BCA ASSESSMENT REPORT

33-35 FAIRLIGHT STREET & 10-12 CLIFFORD AVENUE, FAIRLIGHT NSW 2094

Prepared for: Allen Group Development Pty Ltd C/- Lighthouse Project Management Pty Ltd **Project No:** 240011

Date: 12 December 2024 **Status:** Revision 02

Figure 9 – Movement & Control Joint Details (Source: Section 2.9 of AS 4654.2-2012)

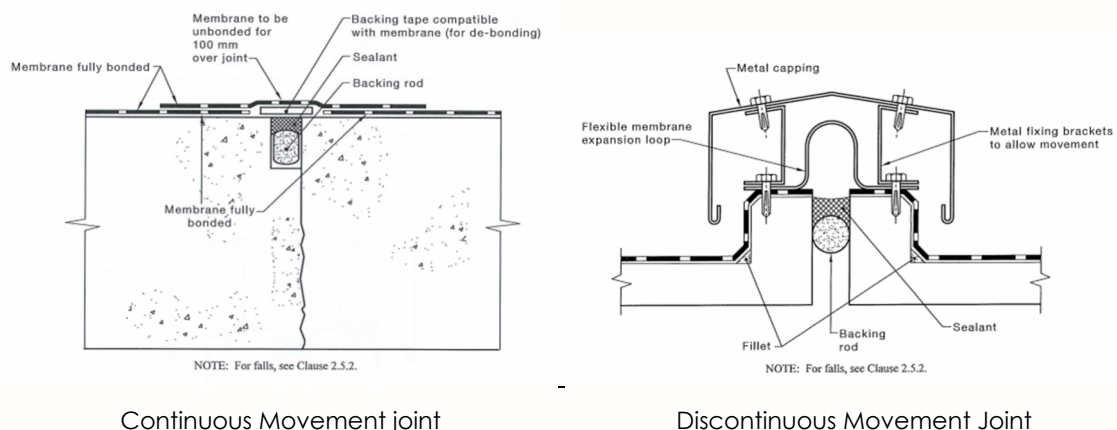
In this regard, it is noted that the current details do not specify control or movement joints and therefore, where these are provided, the Architect /waterproofing consultant is to ensure compliance with the Clause D1D4
